1984 Corvette: Recall: Positive Battery Cable Routing

Subject: Product Safety Campaign 84C04 Positive Battery Cable Routing

Source: Chevrolet Dealer Product Campaign Bulletin

Number: 84C04, Number XII

Figure 1

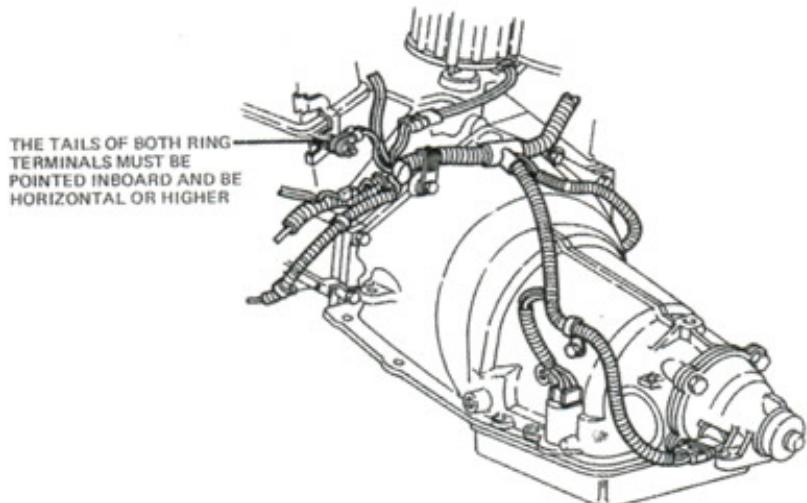
General Motors has determined that a defect which relates to motor vehicle safety exists in certain 1984 Chevrolet Corvettes. The insulation on the positive battery cable may rub against the engine wiring harness bracket or ground stud. If the insulation wears through, it could result in rapid battery discharge and loss of the headlights. Sudden loss of the headlights under severe weather or nighttime driving conditions could reduce driver visibility, which could result in a vehicle crash without prior warning. Rapid battery discharge could also result in loss of operation of other electrical systems.

To prevent the possibility of this condition occurring, Chevrolet Dealers are to install a new engine harness retainer bracket, protective conduit, two(2) cable clips, tie strap and reposition the ring terminals (ground stud) on all involved vehicles in accordance with the Service Procedure outlined in this campaign bulletin.

The bracket may have a bolt or a stud/nut fastener depending on build dates. Retain this fastener.
4. Loosen the ground stud nut on the left hand rear cylinder head and reposition both (2) ground wire ring terminals. Terminals are to point inboard and be horizontal or higher. (Figure 1)
5. Thread the kit supplied conduit over the positive battery cable. The inboard end of the conduit should extend inboard beyond the (ground stud) repositioned ground ring terminals.
